SUSQUEHANNA STEAM ELECTRIC STATION

INVESTIGATION OF UNIT ONE

SMALL PIPING SYSTEM DESIGN

SUSQUEHANNA STEAM ELECTRIC STATION - UNIT 1
REPORT - INVESTIGATION OF SMALL PIPING SYSTEM DESIGN
INSTALLATION AND INSPECTION - PROGRAM ADEQUACY
AND IMPLEMENTATION
AUGUST 3 - 12, 1982

FIGURE A-3.15

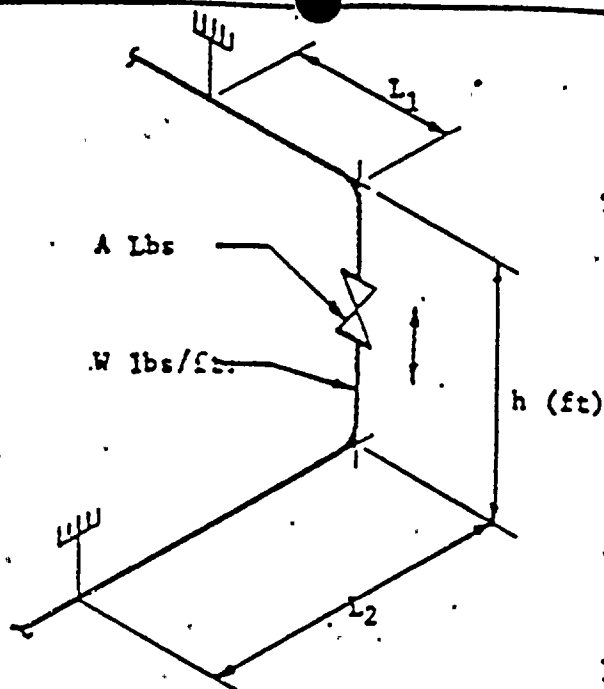
Specification 8856-M-241 (Rev. 3) Appendix A figure A-3.15 presents geometry adjustment factors for concentrated weights and dynamic loads for one piping geometry. As the figure is self explanatory, no additional instructions are provided for its use. The figure states, "F_W/WL = 0.51 to 1.0 ... Multiply maximum span L by F = 0.33."

Contrary to this, calculation #5268 (Rev. 2), sheet 4, span "H2000 to H2011" shows for W/WL = 0.78 ... multiplication of maximum span L by F = 0.42. Investigation indicates that this value of F was obtained by interpolation of the values for F given in figure A-3.15. Such

interpolation of the values for F presented in Figure A-3.15 are not authorized within the specification. Application of this larger value for F, obtained by interpolation, resulted in acceptance of a 2'-5½" span, which should have been identified as being 4½" overlength, by spec M-241 criteria.
